ADDENDUM TO THE CONTRACT DOCUMENTS

ADDENDUM NO. 001
	Project: Solano Community College District Building 1600 Mechanical Room Upgrade Project Project Number: 25-027
	Date: March 16 th , 2026

PARTICULARS**1.01 DATE: 03/16/26****1.02 PROJECT: 2510-00648-00 B-1600 MECHANICAL ROOM HYDRONIC UPGRADES****1.03 OWNER'S PROJECT NUMBER: 25-027****1.04 OWNER: SOLANO COMMUNITY COLLEGE DISTRICT****1.05 ARCHITECT: SALAS O'BRIEN****TO: PROSPECTIVE BIDDERS:****2.01 THIS ADDENDUM FORMS A PART OF THE CONTRACT DOCUMENTS AND MODIFIES THE ORIGINAL DOCUMENTS DATED 02/25/26, WITH AMENDMENTS AND ADDITIONS NOTED BELOW.****2.02 ACKNOWLEDGE RECEIPT OF THIS ADDENDUM IN THE SPACE PROVIDED IN THE BID FORM. FAILURE TO DO SO MAY DISQUALIFY THE BIDDER.****2.03 THIS ADDENDUM CONSISTS OF 25 PAGE(S) AND THE FOLLOWING DRAWINGS:
CHANGES TO THE PROJECT MANUAL - SPECIFICATIONS:****3.01 SECTION 09 90 00 - PAINTING AND COATING**

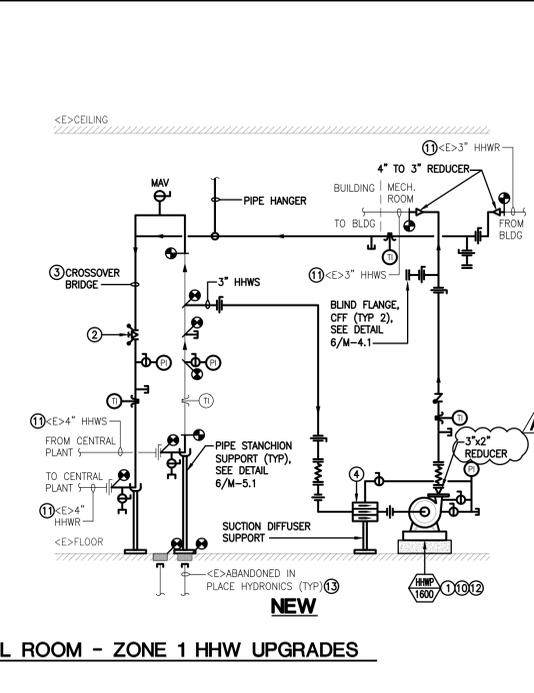
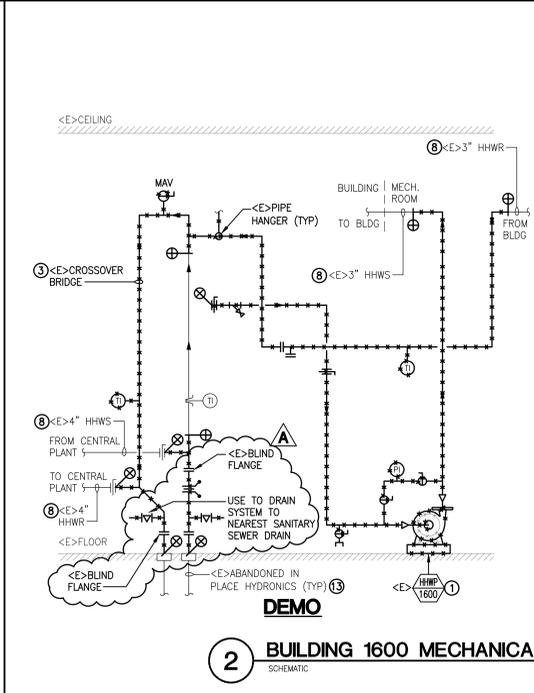
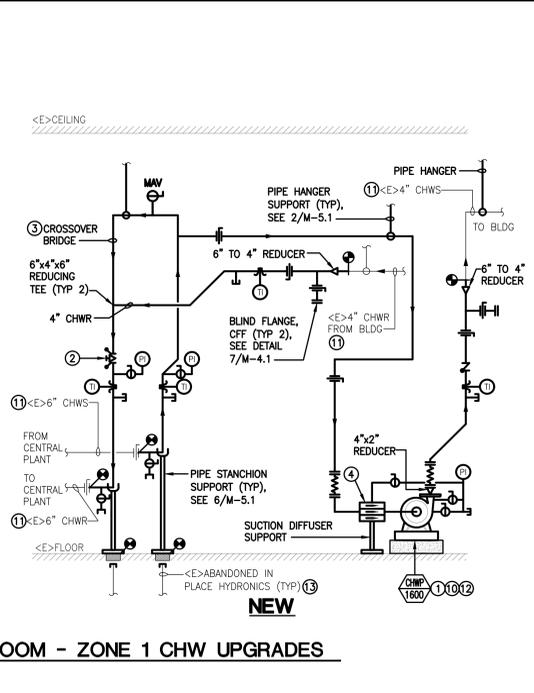
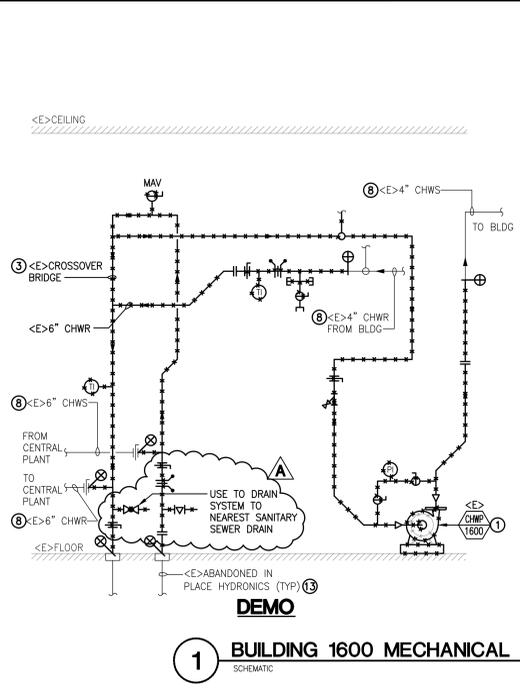
- A. General revisions were added for clarity.
- B. General Sheet Note E. was added for isolating and draining sections of work.
- C. HHW and CHW Upgrades schematics have been revised.
- D. Revisions to CHW and HHW BOM were added for clarity.

M-4.2
 SHEET OF

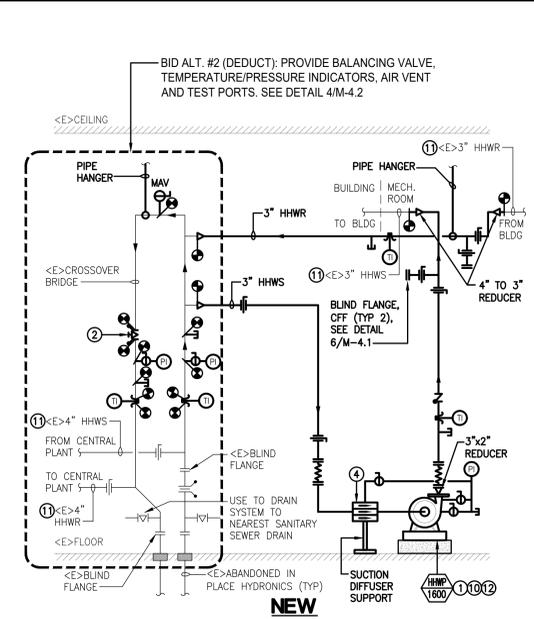
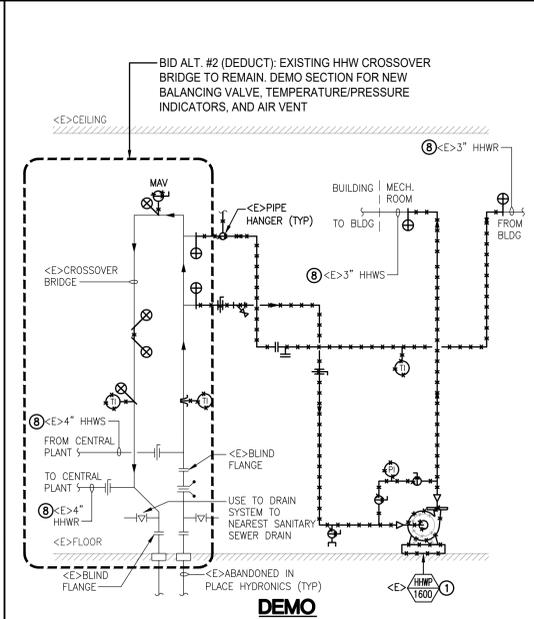
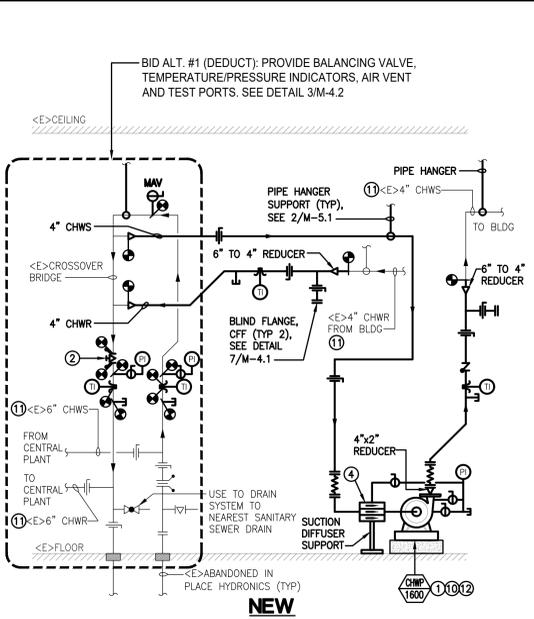
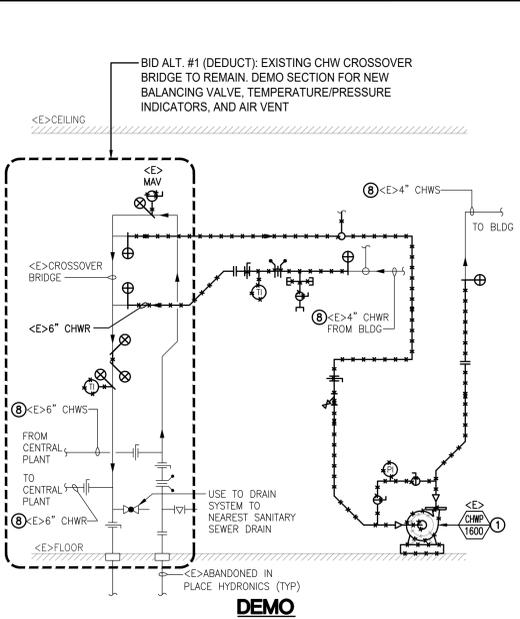
- A. Sheet M-4.2 was added in it's entirety for Bid Alternates #1 and #2 and reflected on G-0.0.
